Subj: PROPOSED ADDITIONAL FIELD WORK AT SITES 4 AND 5 FOR THE RI/FS,
NAS ALAMEDA

**PROPOSED ADDITIONAL FIELD WORK AT SITES 4 AND 5 FOR THE RI/FS,
NAS ALAMEDA**

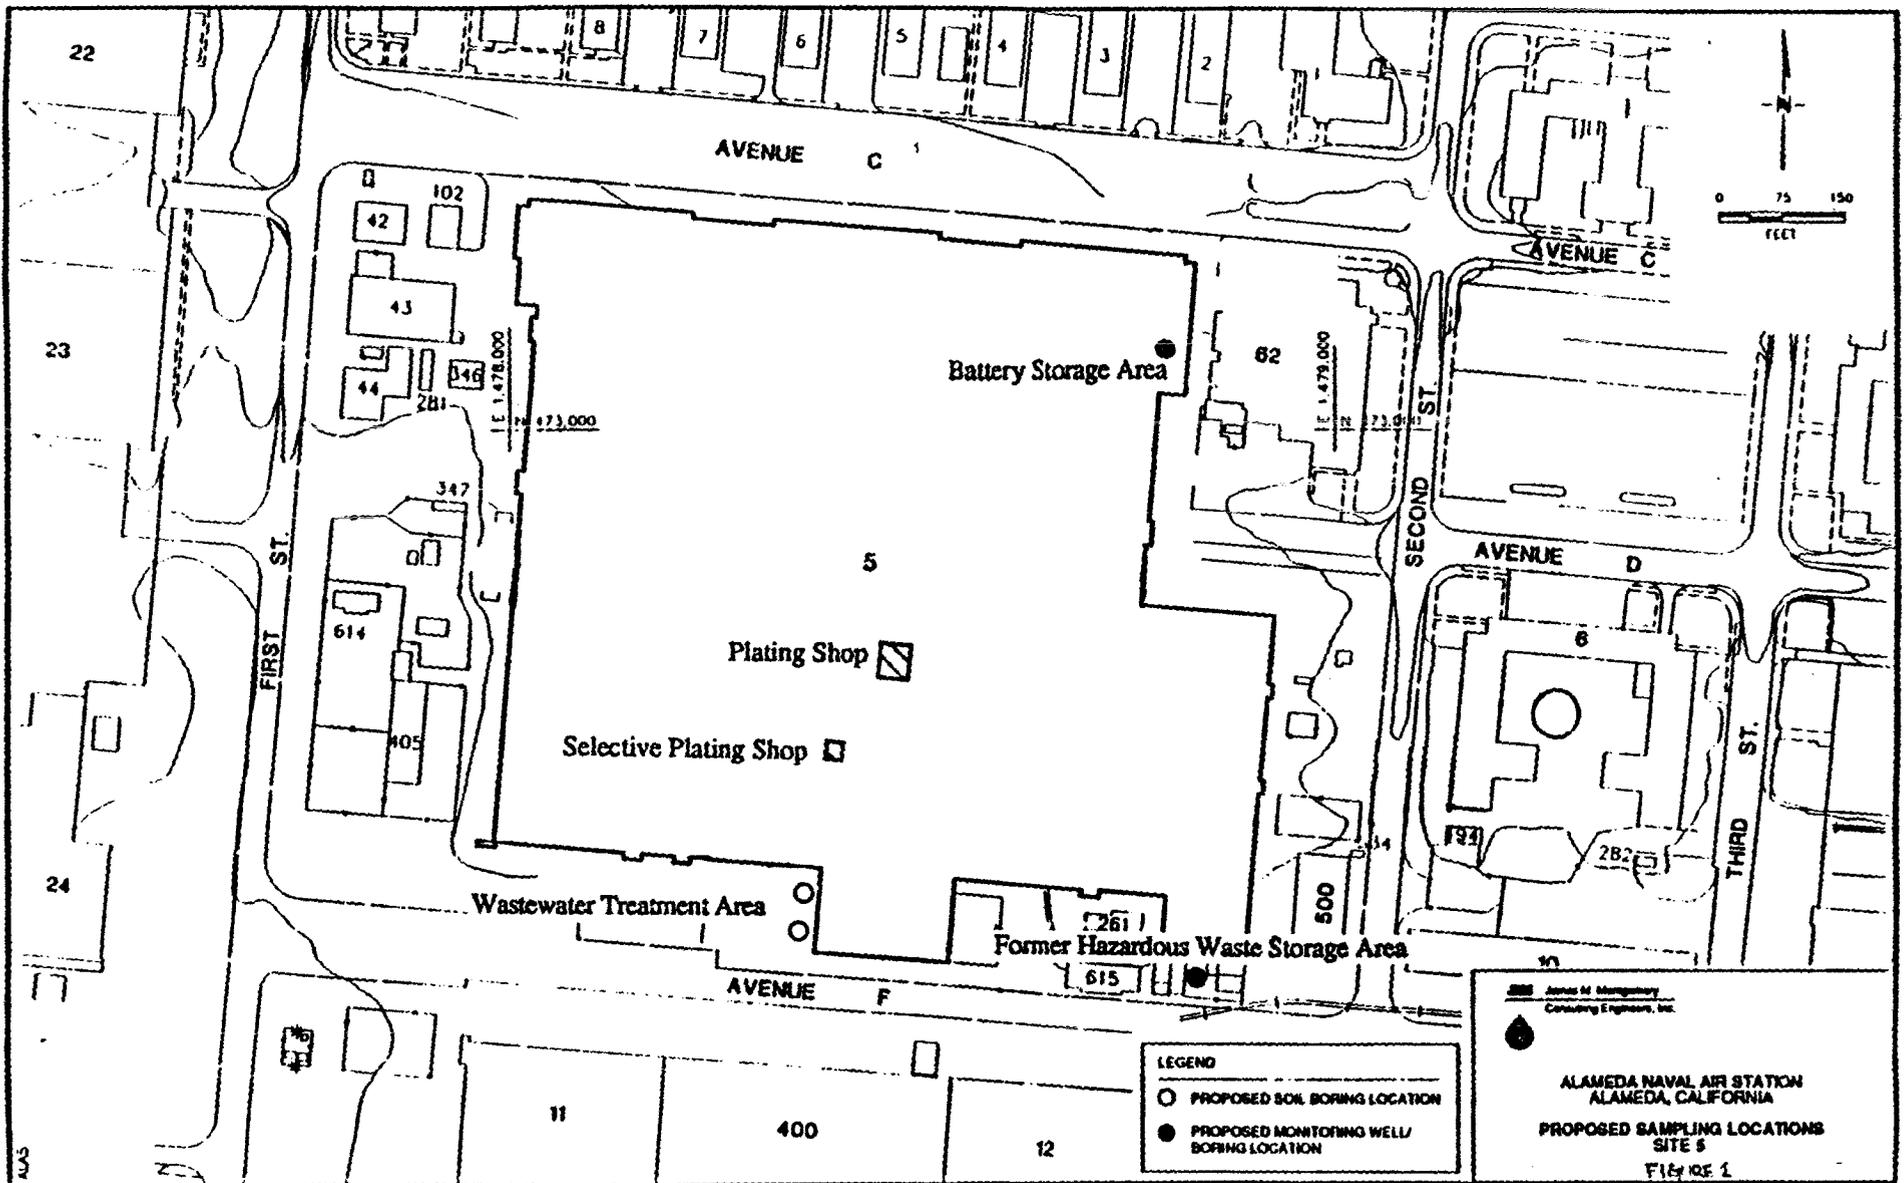
Wastewater Treatment Area. Two boreholes will be drilled to a depth of approximately 15 feet in the wastewater treatment area, adjacent to the sumps used to store wastewater prior to pretreatment (Figure 1). The boreholes will be drilled with hollow stem augers. One borehole will be drilled adjacent to the cyanide wastewater sump; one borehole will be drilled adjacent to the chromium wastewater treatment sump. One soil sample will be collected from each borehole at a depth adjacent to or approximately one foot below the bottom of the sumps. In addition, a grab groundwater sample will be collected from the open boreholes. The soil samples will be analyzed for HSL metals plus hexavalent chromium, cyanide, VOC, TS, semivolatile organic compounds (SVOC), and pH. One randomly chosen soil sample will be analyzed for TOC. Groundwater samples will be analyzed for HSL metals plus hexavalent chromium, cyanide, VOC, SVOC, and total dissolved solids (TDS).

Former Hazardous Waste Storage Area. One borehole will be drilled in the area formerly used to store drummed waste (Figure 1). The borehole will be drilled to a depth of 15 feet using a truck mounted rig equipped with hollow-stem augers. Soil samples will be collected continuously from the ground surface to the total depth of each hole. A total of four soil samples from the borehole (one surface, three subsurface) will be retained for chemical analysis. Soil samples will be analyzed for HSL metals plus hexavalent chromium, cyanide, pH, TS, VOC, and SVOC. In addition, one randomly chosen soil sample from the borehole will be analyzed for TOC.

Battery Storage Area. One borehole will be drilled in the battery storage area (Figure 1). The borehole will be drilled to a depth of 15 feet using a truck mounted rig equipped with hollow-stem augers. Soil samples will be collected continuously from the ground surface to the total depth of each hole. A total of four soil samples from the borehole (one surface, three subsurface) will be retained for chemical
